Project Carlow Library Extension

Report Title Stage 2a Report

Our Ref DI/4502/R1 Issue 1

Report No. DI/4502/R1
Issue No. Issue 1
Issue Date. 08/12/2020

Title
PROPOSED BASEMENT PLAN

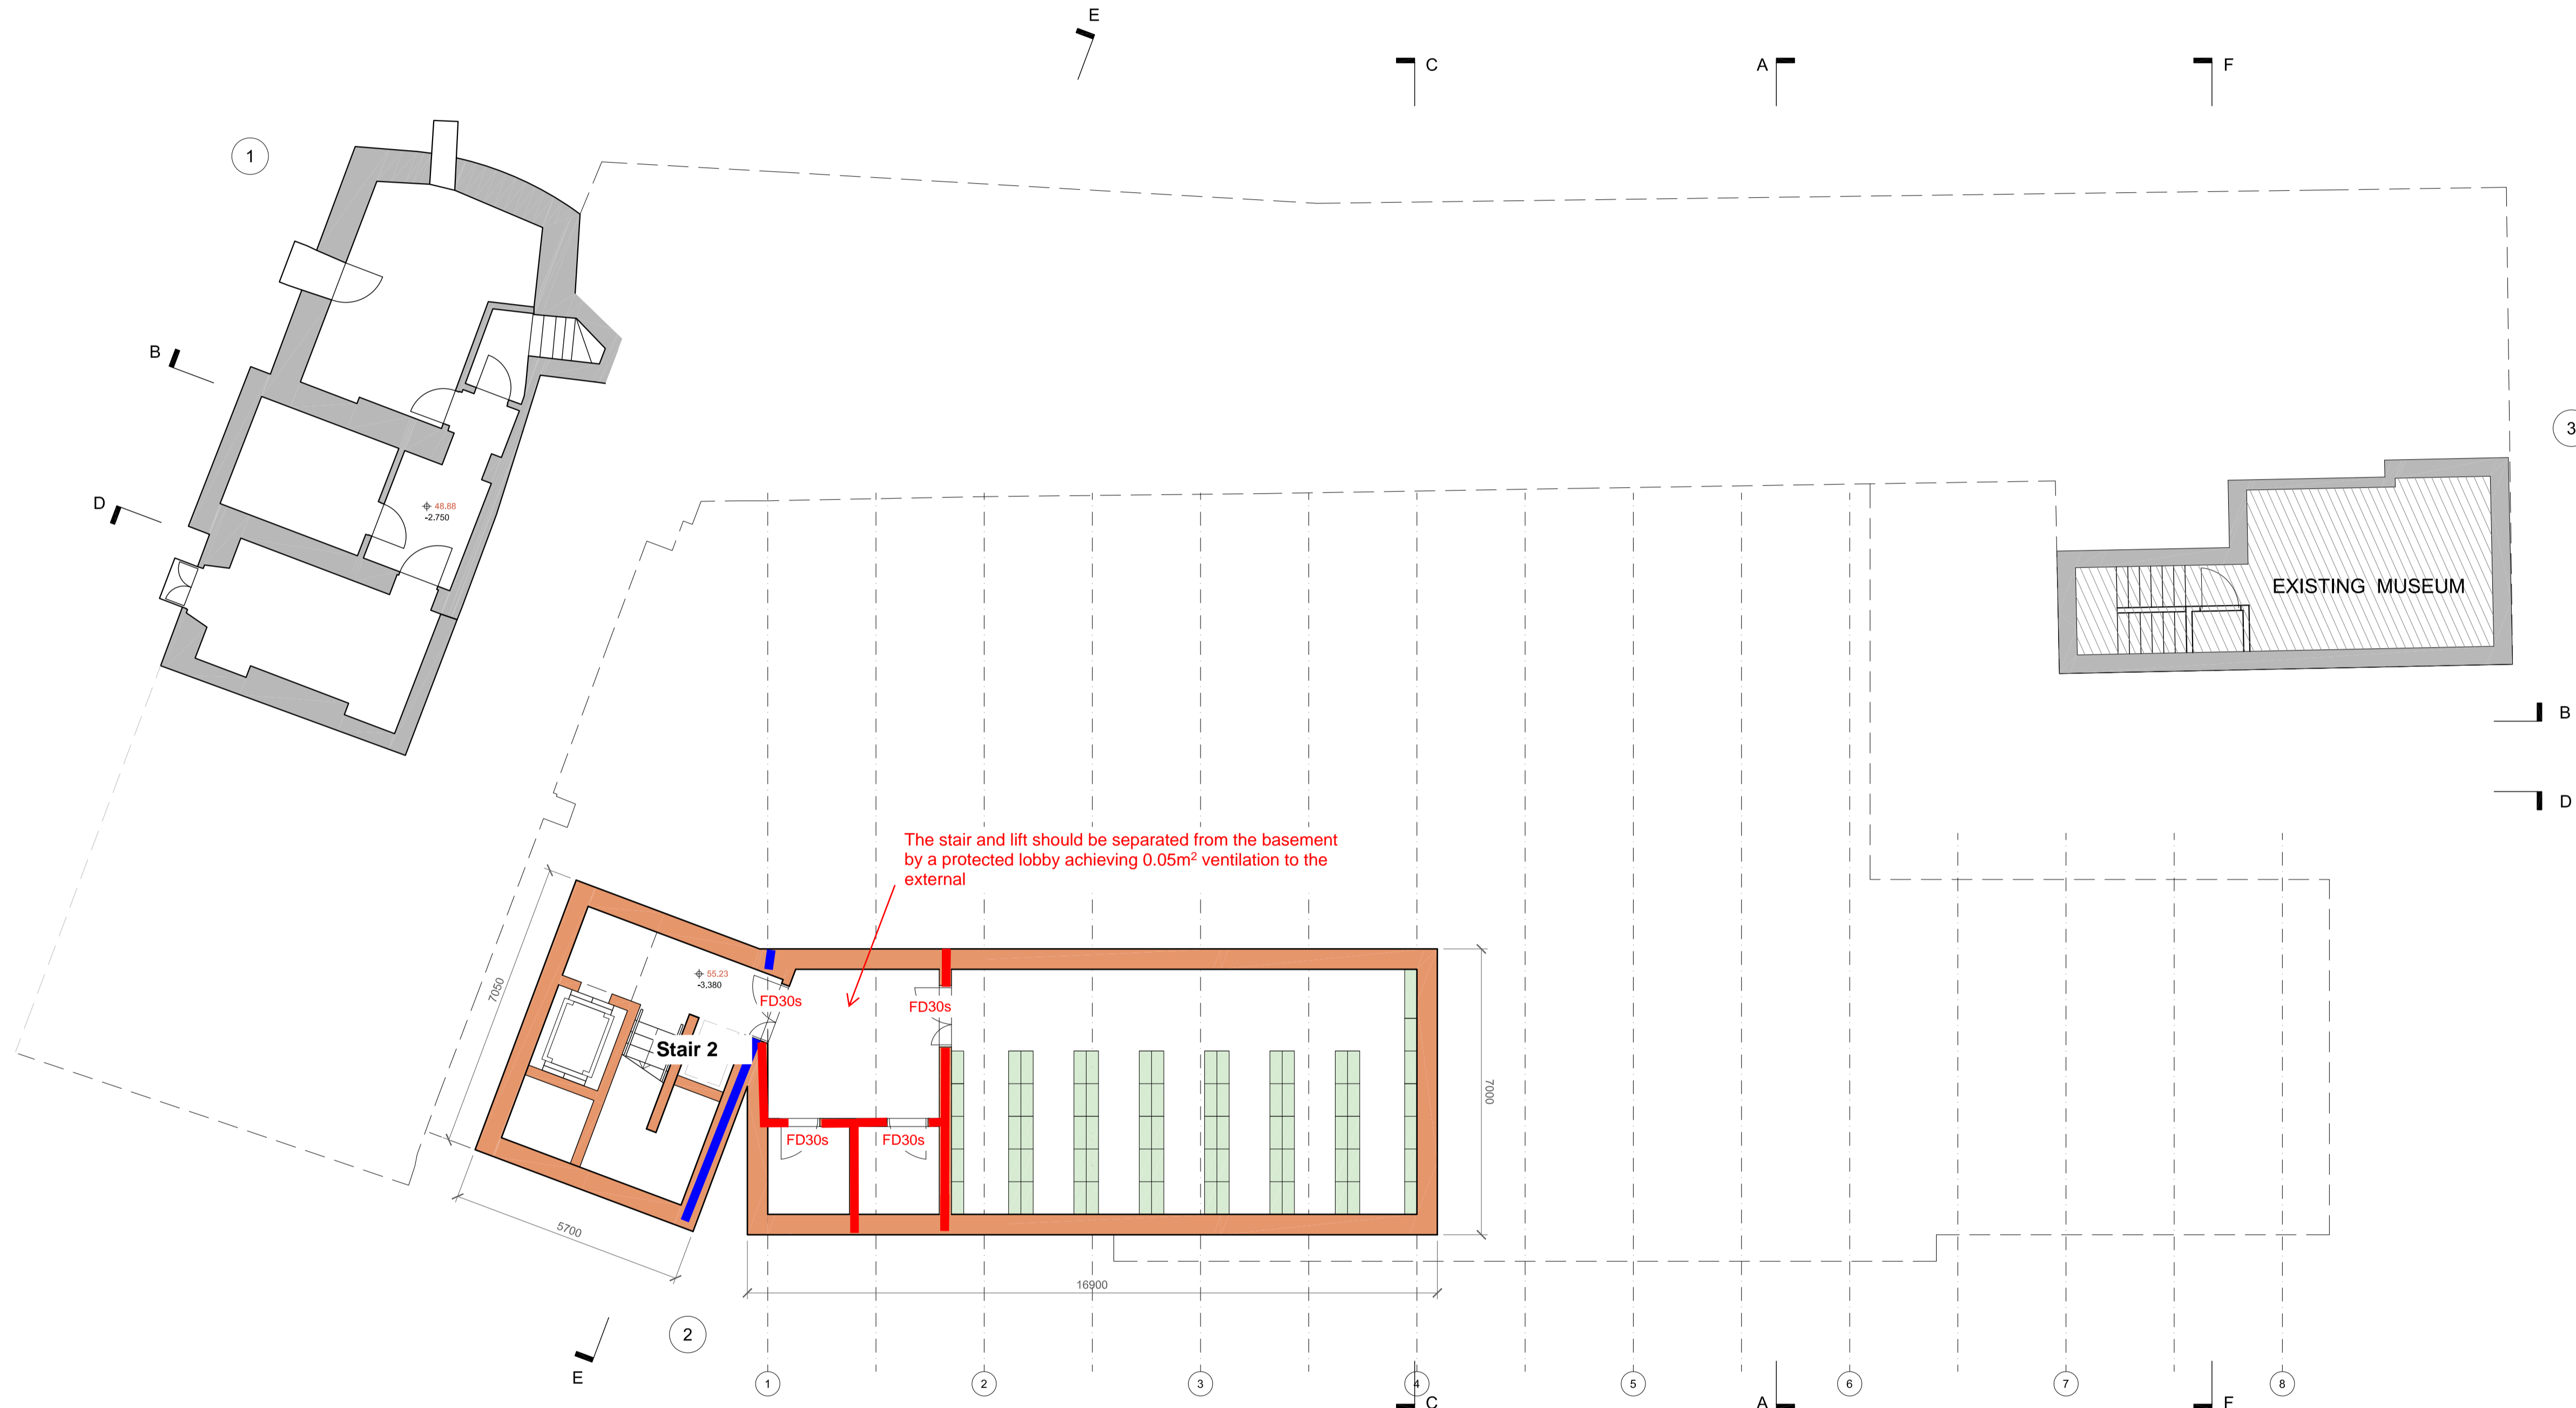
The escape stair and lift should be separated from the basement by a protected lobby achieving 0.05m² ventilation to the external.

| Rev | Description | Date |
|-------------|---|----------|
| Title | PROPOSED GROUND FLOOR PLAN | |

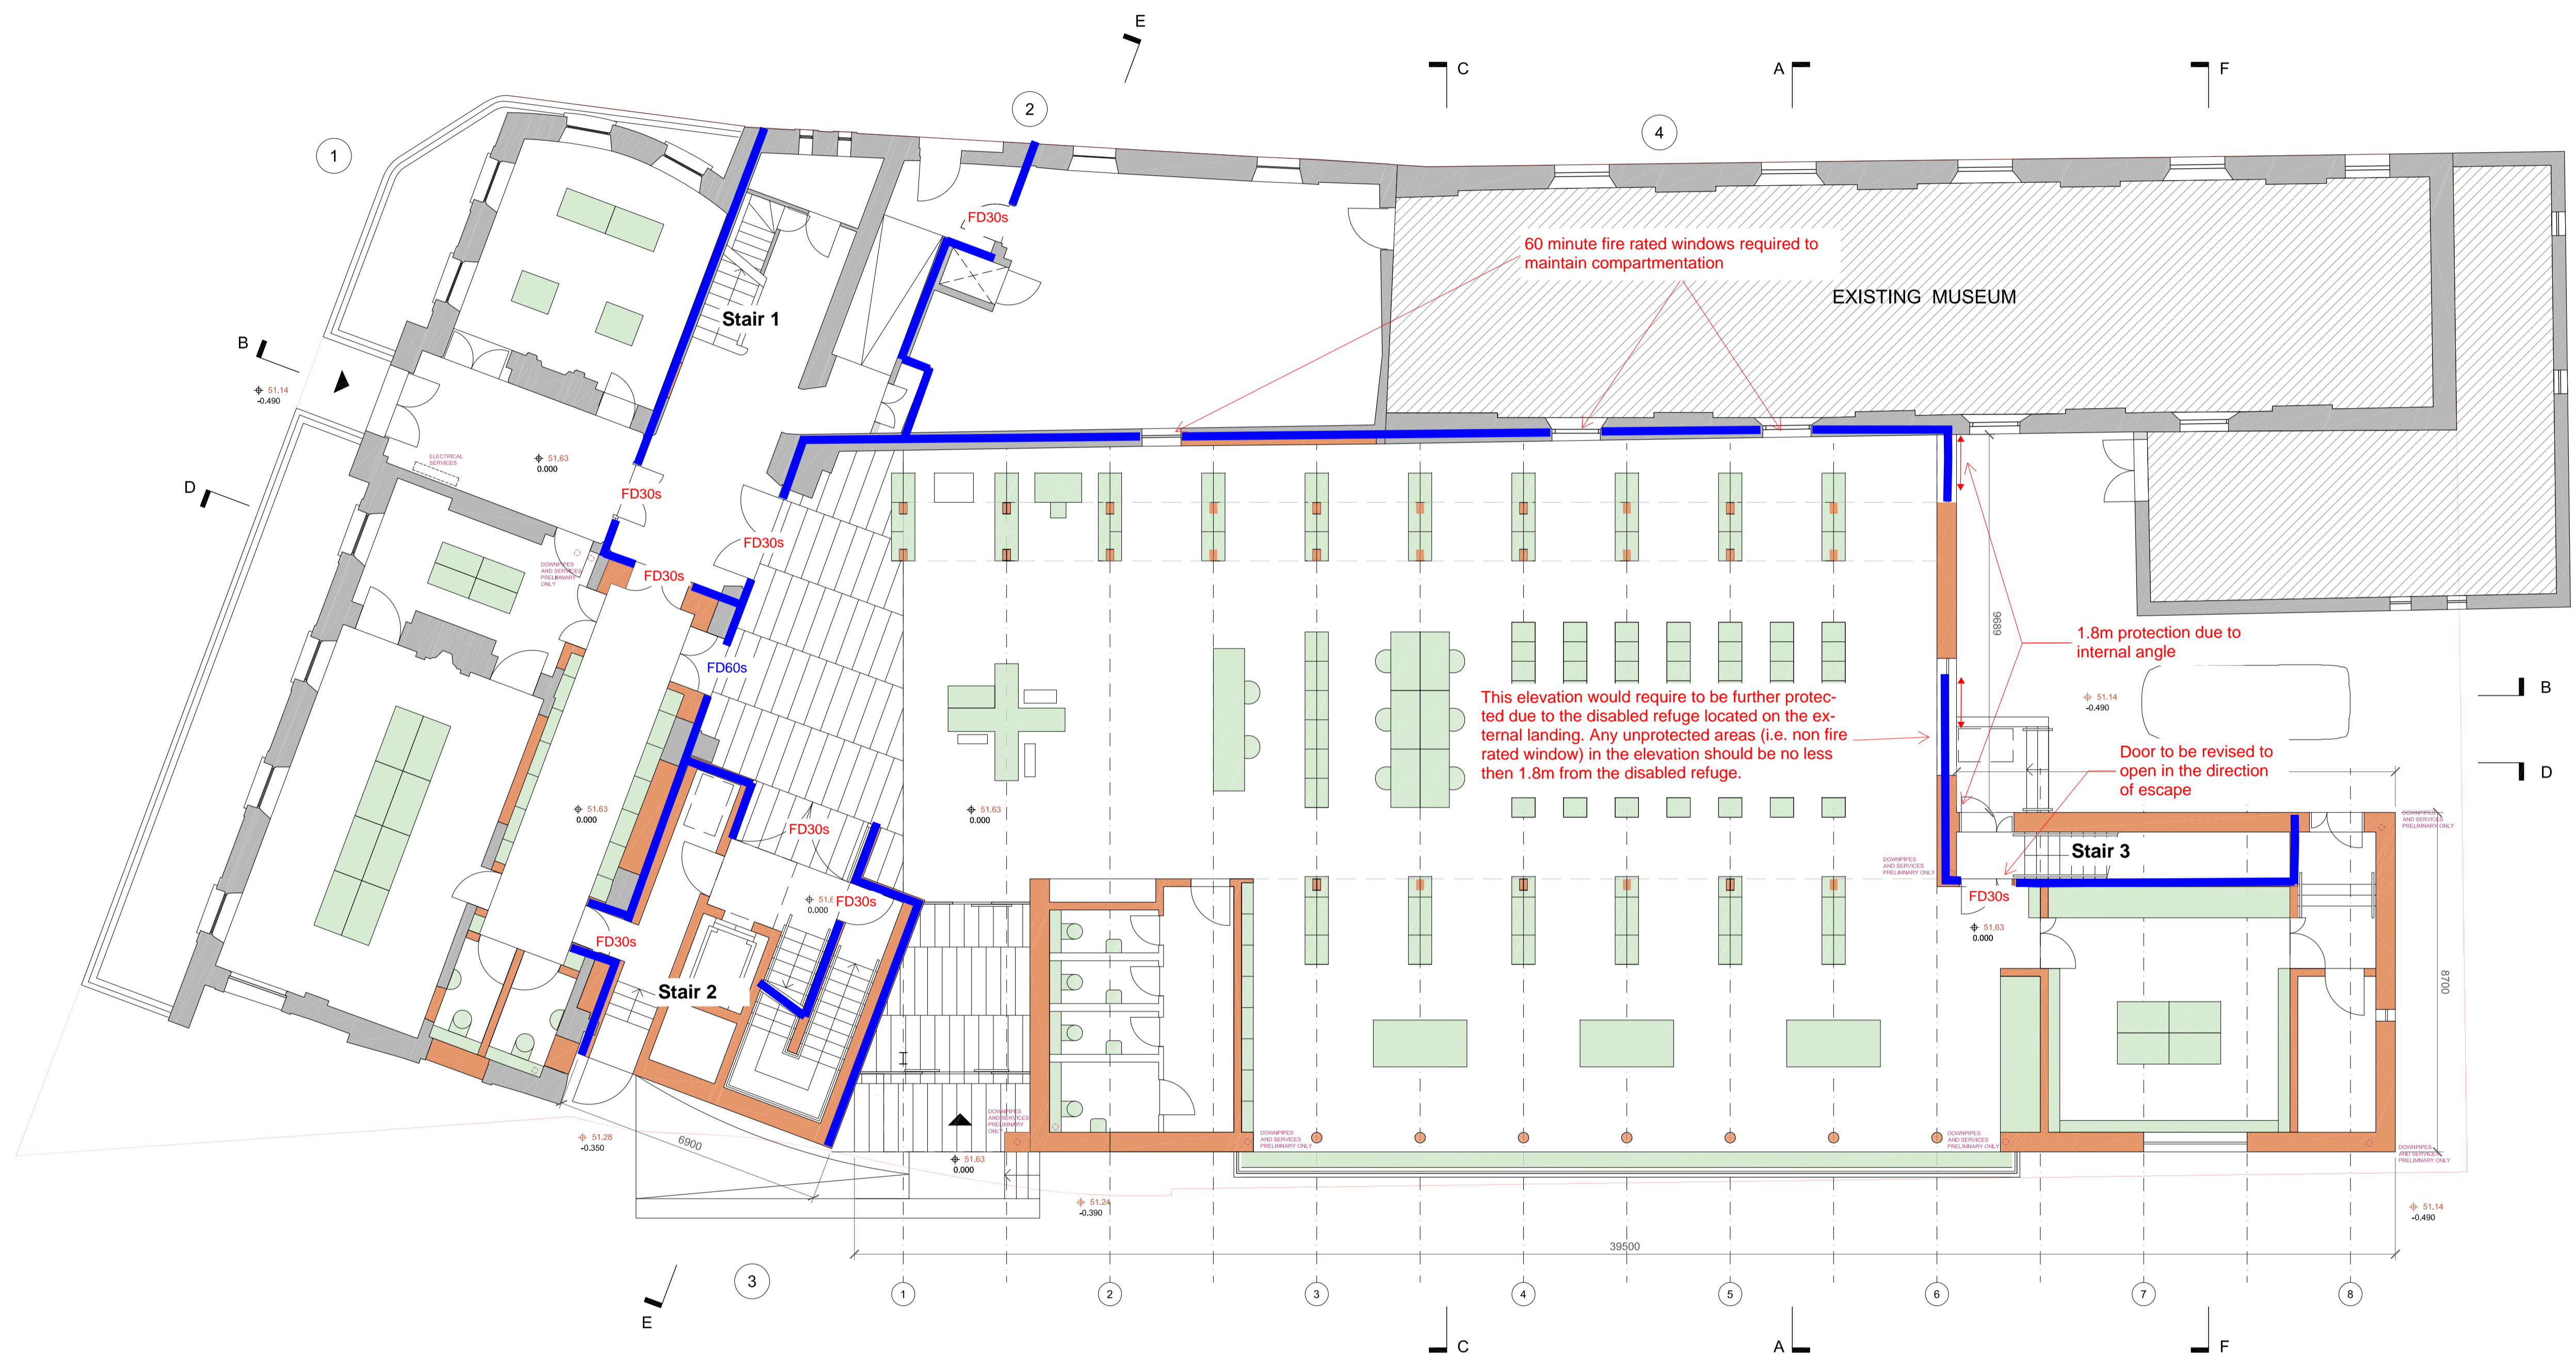
The storey exit into stair 3 at ground level from the main library should be revised to open in the direction of escape.

The final escape from Stair 3 to outside is adjacent to the elevation/window of the main library space at ground floor. Therefore, in the event of a fire within the ground floor library, escape from Stair 3 may be compromised. In accordance with code guidance, it is recommended that the escape route from Stair 3 is fire separated from the adjoining elevation, particularly any adjacent windows, so that the escape route remains available in the event of fire.

The junction of the external walls of escape stair 3 and the adjacent accommodation needs to be fire rated (for 60 minutes) to a distance of 1.8m along the main library space elevation.

The disabled refuge proposed outside the final exit to stair 3 cannot be considered to be in a place of relative safety, if located beside a non-fire rated window, where the occupant could be exposed to fire conditions within the building. If it is intended to leave the disabled refuge outside a minimum distance of 1.8m should be maintained between any unprotected areas (i.e. non fire rated window) and the disabled refuge.
